Intermodal Transp. facility

September 14, 2012

**RE: University of New England - Patient Care Center
Application #2012-483; CBL 145-B-024
Intermodal Transportation Facility at 172 Bishop Street**

Figure 2

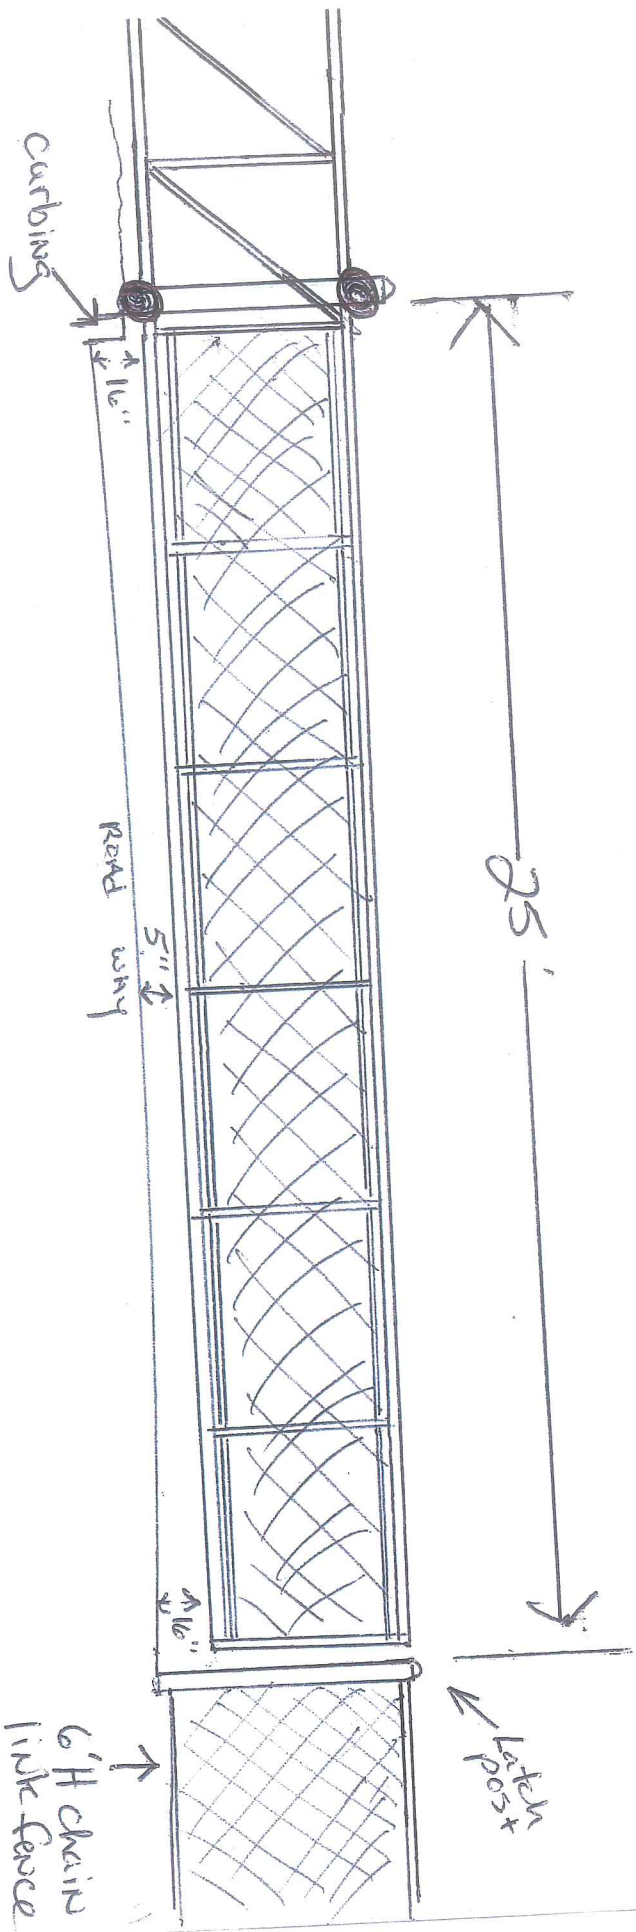
In support of this application we have also included the review of the turning radius required for the bus to turn around at the shelter locations. Maine Traffic Resources has determined that there is adequate space for the turning movements, and the upper parking spaces will be blacked out accordingly to allow for this.

Typical Double Swing gate

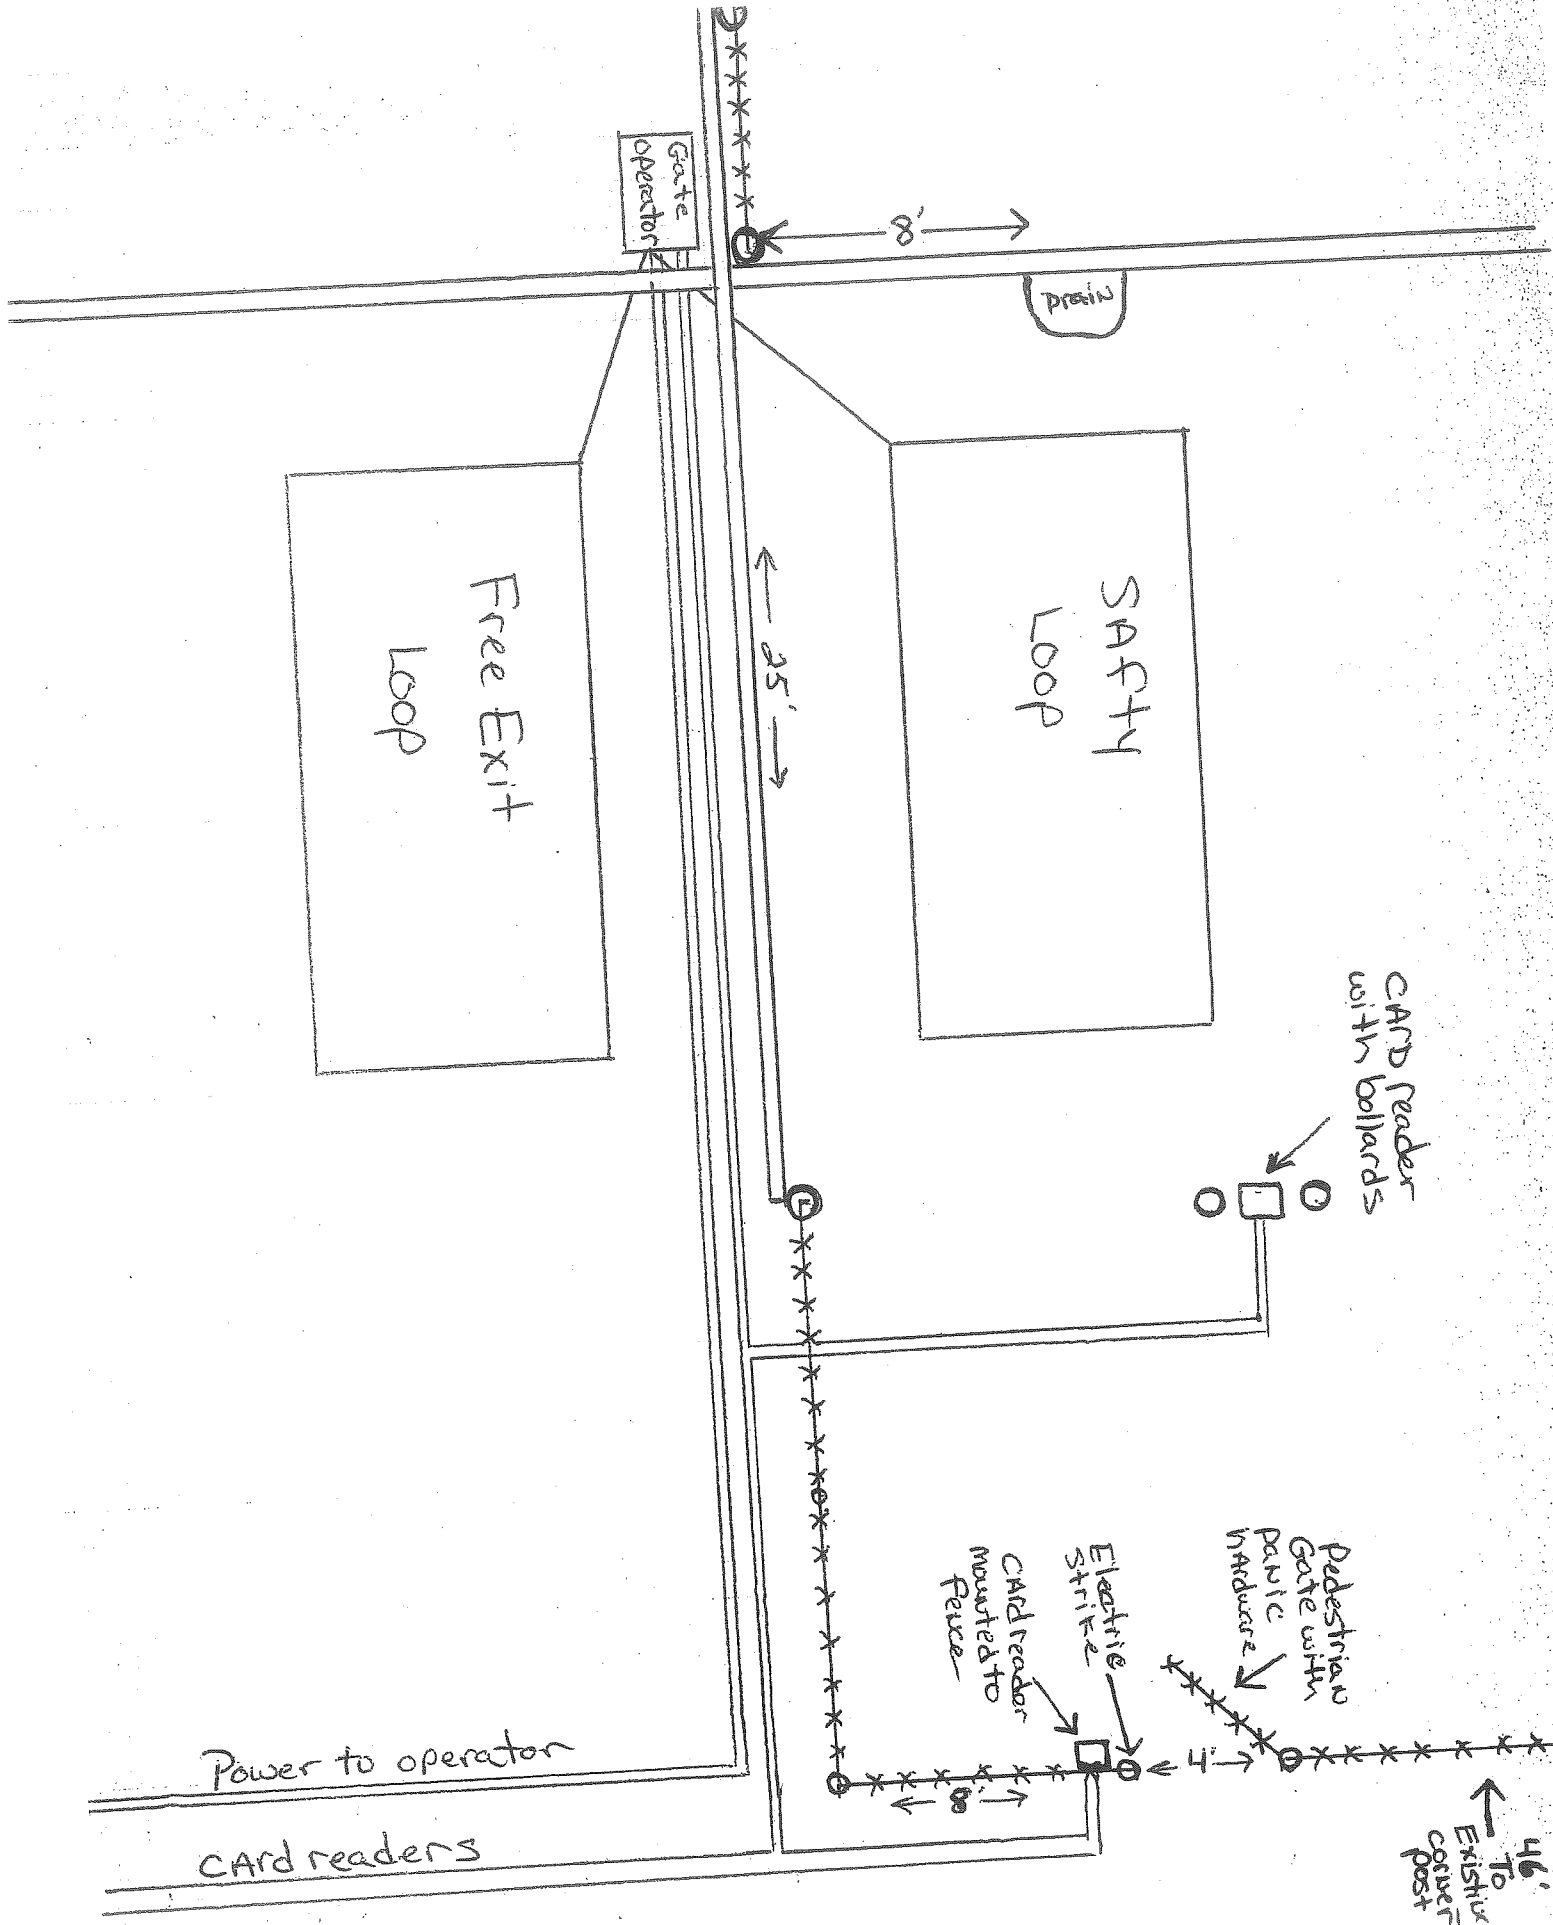
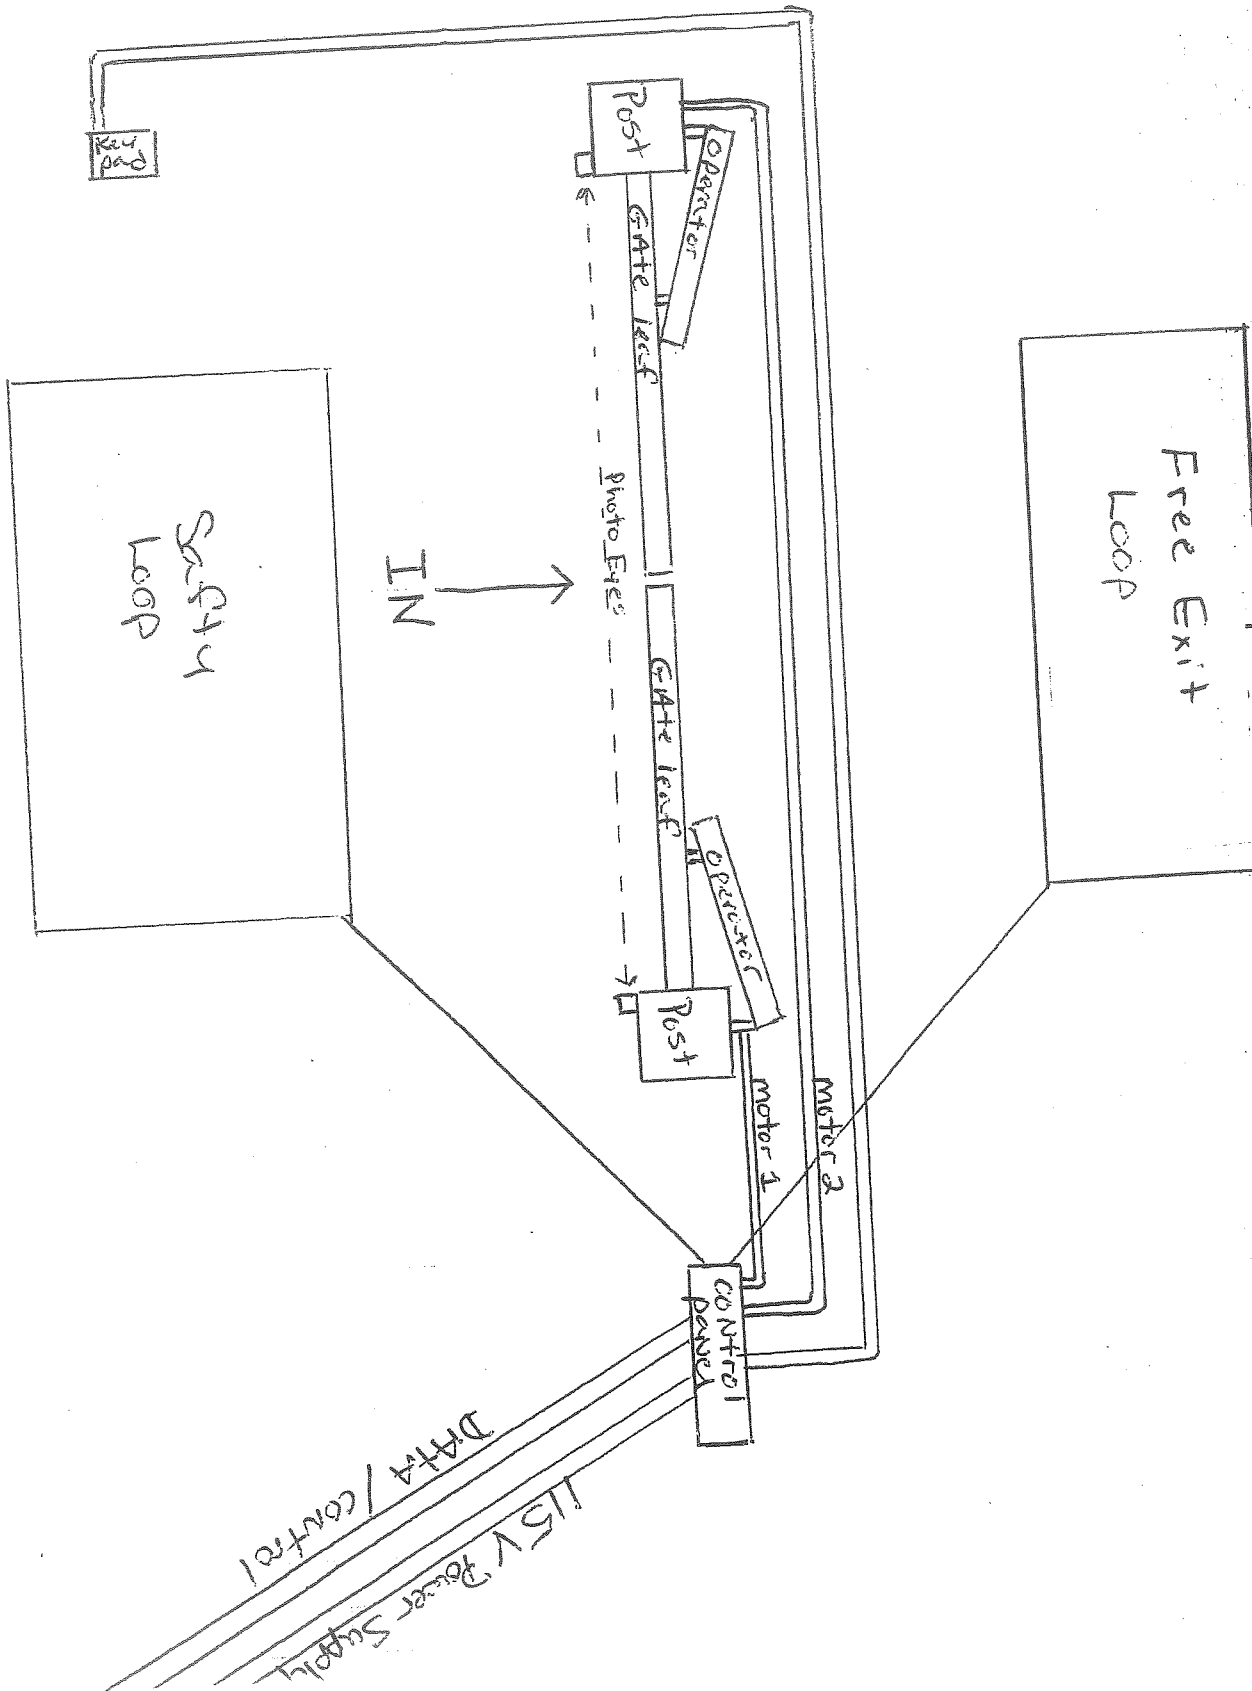
Details of the gates are attached. The gate at the Bishop Street site has been moved back into the site, and will remain open during normal business hours, so there will be no stacking in the street. The gate at the Bishop Street end of the access road has been located well into the site, and will remain closed. The shuttle bus and the UNE Security vehicles will have remote control operators to open the gate well before they arrive in order that they can drive through without stopping. This feature will also be incorporated in the design of the gate at the College Street end of the access road, which will also remain closed.
